CITY PLAN COMMISSION**THURSDAY, April 23, 2026****FILE NUMBER:** PLAT-26-000088**SENIOR PLANNER:** Hema Sharma**LOCATION:** between Commerce Street and Clover Street, west of Malcom X Boulevard**DATE FILED:** March 26, 2026**ZONING:** PD 269 (Tract A)**PD LINK:** <https://dallascityhall.com/departments/city-attorney/Articles/PDF/Article%20269.pdf>**CITY COUNCIL DISTRICT:** 2**SIZE OF REQUEST:** 0.7190-acres**APPLICANT/OWNER:** AP Blanton Deep Ellum, LLC

REQUEST: An application to replat a 0.7190-acre tract of land containing all of Lot 1A in City Block 13/191 to create one 0.1434-acre lot, one 0.2902-acre lot and one 0.2854-acre lot on property located between Commerce Street and Clover Street, west of Malcom X Boulevard.

PRELIMINARY PLAT
COMMERCE ASANA ADDITION
LOTS 1B, 2A & 3A BLOCK 13191
 31,318 Square Feet, 0.7190 Acres
 Being a Report of
 Survey for
 of COMMERCIAL MALCOLM ADDITION
 as recorded in 202405404.
 Official Public Record, Dallas County, Texas
 JOHN GIBSON SURVEYOR, LICENSE NO. 485
 City of Dallas, Dallas County, Texas
 File No. Plat-26-000088
 METERS 18, 2024
 SHEET 1 OF 2

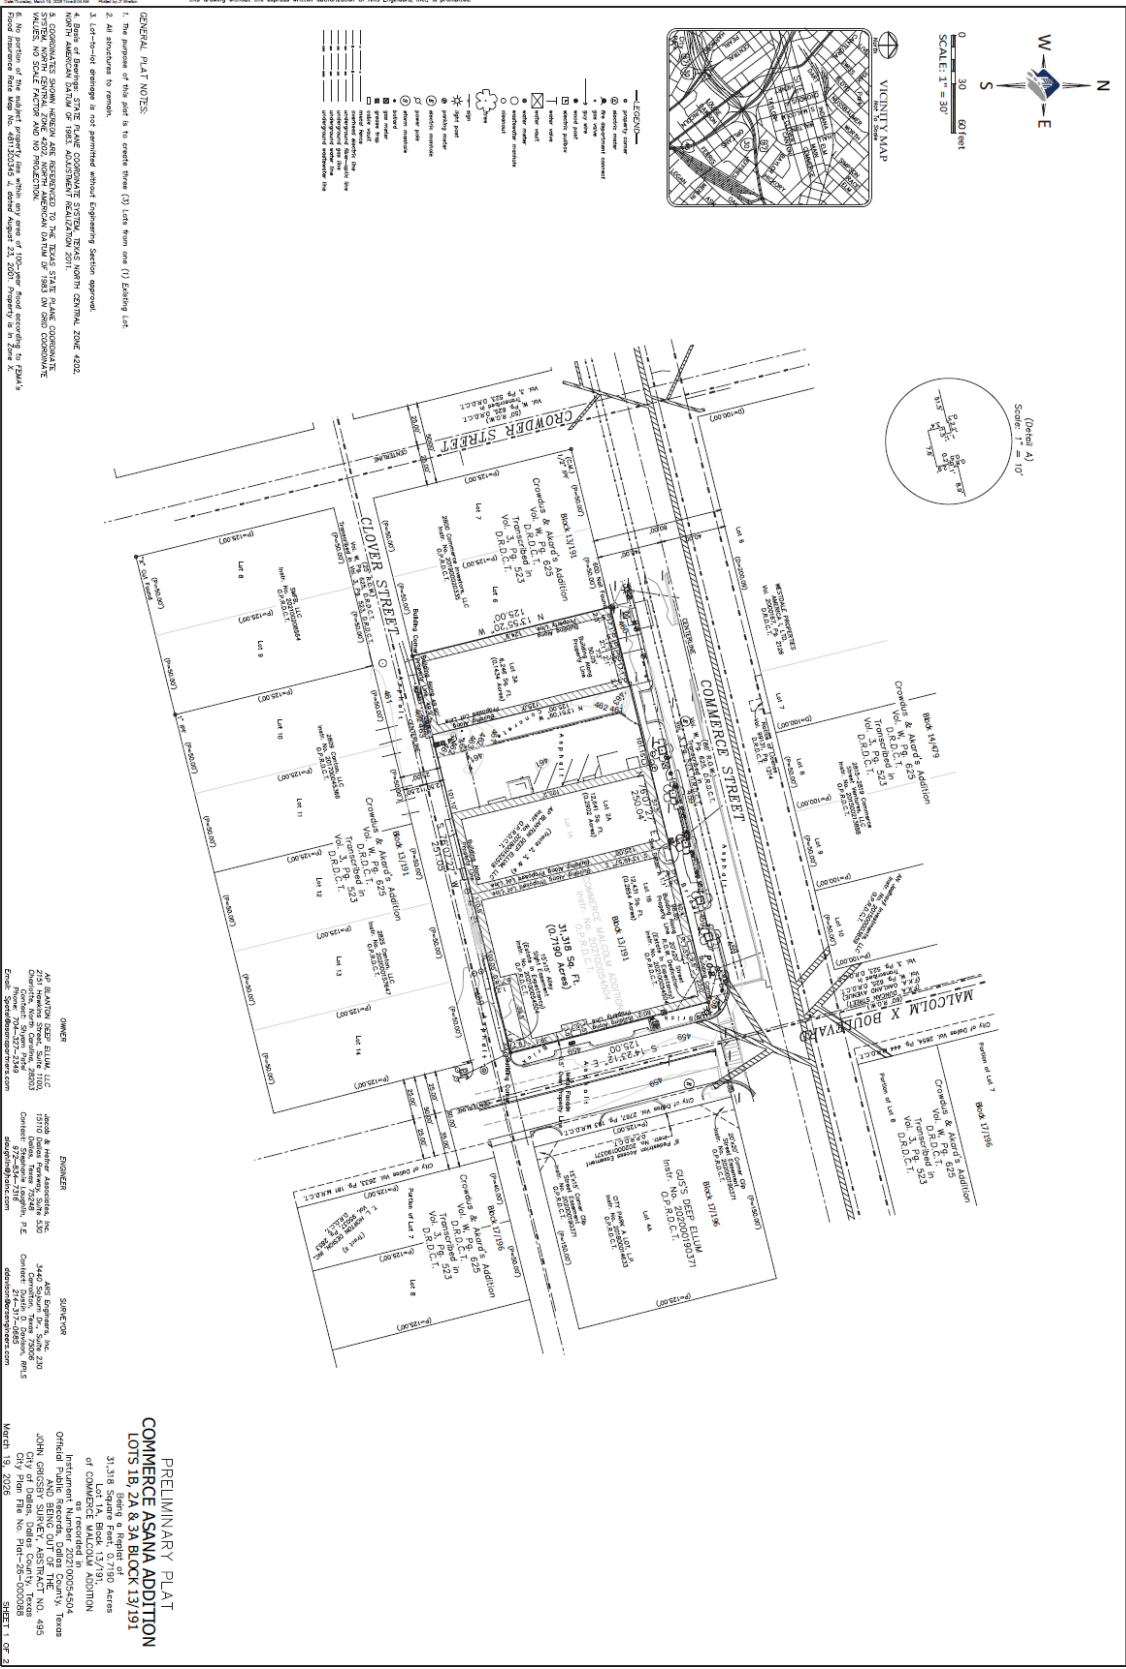
15. On the final plat, dedicate 28 feet of right-of-way (via fee simple or street easement) from the established centerline of Clover Street. *Sections 51A-8.602(c), 51A-8.604(c) and 51A-8.611(c).*
16. Must coordinate with Transportation Department for any traffic signal requirements that are deemed necessary for improving pedestrian accessibility and safety related to site development (Contact Srinivasa Veeramallu with Traffic Signals). *51A-8.606, 51A-8.608*
17. Comply with Mill Creek drainage requirements. Finish floor elevation must be 3' above nearest inlet, top of curb. *51A 8.611(d), C.9 of Mill Creek, Master Drainage Plan Study*

20. On the final plat, change "Crowder Street" to "Crowdus Street". Section 51A-8.403(a)(1)(A)(xii).
21. On the final plat, add "Canton Street (FKA Williams Street)" to plat drawing.
22. On the final plat, identify the property as Lots 1B (east lot), 3A, & 4A in City Block 13/191.
